MEMORANDUM

TO: PAM HARRELL **COMPANY:** CITY OF COLUMBUS
FROM: I.B. STOREY U.S. INC.
SUBJECT: 24-021 HAMILTON CC & ICE ARENA – CLARIFICATION MEMO
DATE: 12-DEC-24

Figure 1: New Refrigeration Panel by Others.

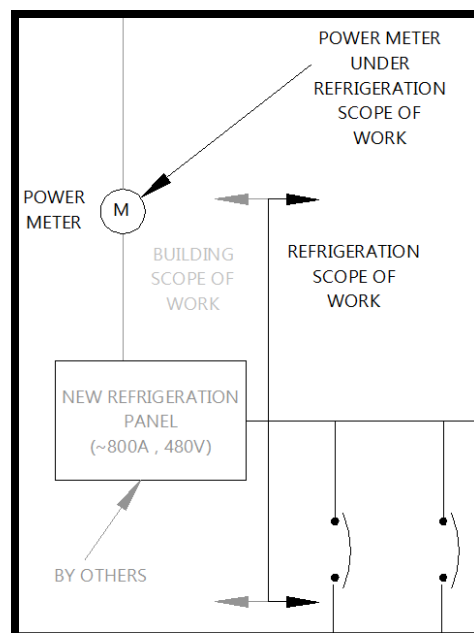
- New refrigeration panel and main connections to building should be included in electrical scope for dressing room expansion. The refrigeration plant contractor is to connect to plant equipment to the refrigeration panel.
